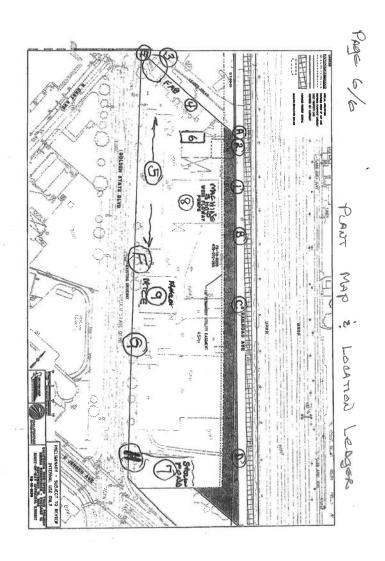
- 2. As shown on the attached map, the front portion of the administrative building is eliminated by the HSR right of way (Building 2). This is a very active and necessary part of the Floway business and this building will need to be replaced before this portion of the right of way is taken and the building is destroyed. It is unclear now if this building can be redesigned to allow a second floor to be constructed to replace the space eliminated by HSR. If this is not possible a new administrative building may need to be constructed on the southern portion of the site.

4. Plant deliveries which include semi-truck loads of 40-foot long steel need to be able to access the Fabrication Shop (Building 4). Without access from Railroad Avenue this will not be possible. One alternative is to relocate the Test Laboratory (Building 3) so that these large loads can access the Fabrication Shop from the intersection of Golden State Avenue and East Avenue (Location E). The Test Laboratory could be relocated to the southern portion of the site perhaps in the area of the current storm drain pond to be outside of the contaminated soil on Parcel 18 on the southern part of the property. This building contains a test pit which would avoid contaminated soils if installed in this area.

6. Building 5 on the attached map will need to be removed to allow access to the site from Golden State Boulevard and to allow proper access to this building. This building houses inventory control (raw and semi-finished pump components) and assembly, paint and shipping and receiving. This building has the only shipping dock on the site where large material can be loaded onto tractor trailers. A tractor cannot access the loading dock if the Railroad Avenue side of the plant is eliminated. A potential new location for this building would be south of the Machine Shop (Building 8) along the HSR right of way.

9. New access and egress lanes would need to be constructed along Golden State Boulevard for plant personnel and plant deliveries and shipments. Locations E. F. G and H are proposed as access gates to facilitate plant deliveries (E and F), shipping and receiving (F and G) and personnel parking (G).

The Authority is aware of the ongoing remediation efforts by Floway and The Vendo Company and will account for those activities during final design and construction. Responses to the individual comments are provided in Comment Responses 802 through 841.

#### Dairy - 7615 71/2 Avenue (Figure B-7)

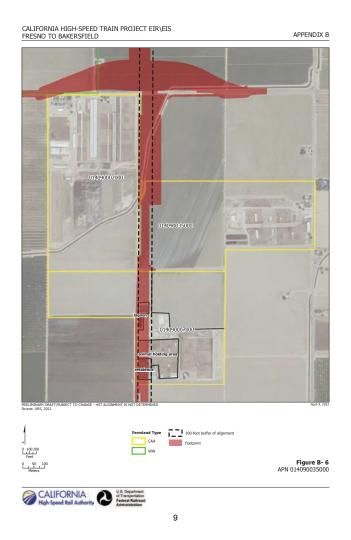
Question re Calif HST project Revised DEIR/Supplemental DEIS, Fresno to Bakersfield Section Appendix 3.14, Figures B-6 and B-7. What do the green and yellow outlines around some parcels mean, Stakeholder Comments/Issues :

We will have to relocate/replace the deep water irrigation well. The relocated well must have a 50 foot seal, and be per California well standards. The cost will include power to the new well location. RWQCB will require that a Well Log should be taken by a professional hydrogeologist. The data from the well log will be required for a new RWQCB Report Of Waste Discharge and a new Monitor Well Installation and Sampling Plan reflecting the modified dairy facility and operations. A new evacuation plan will have to be provided for the county HMBP. We will have to install new manure water storage lagoons lined with double high density polyethylene liners, with gravel and Lysimeters or leak detectors, approved to meet RWQCB Tier I standards. A Geo-boring study and Construction Quality Assurance Plan must be prepared for RWQCB by a Civil Engineer. An Operation

We currently have 86 acres of crop field land. The HSTROW will remove 10.1 acres, or a 12% loss of crop field land to which waste water is applied. Reduced acreage means reduced herd capacity and diminished economic stability for our entire operation. If we are forced to reduce our herd size by 12%, our percent loss of net revenue will be much greater, because our income will reduce by 12% but our fixed costs will remain the same. The dairy has loans and commitments which need its current income to service. It is not certain that the dairy could survive with a reduced herd until we find other waste water land to rent or purchase, which could take years. The dairy's property values, much diminished due to proximity to the HSTROW, will make credit more difficult to obtain once replacement waste water land is found. In general, HSR's forcing of herd reductions may cause dairy foreclosures if they cannot weather the financial impact.
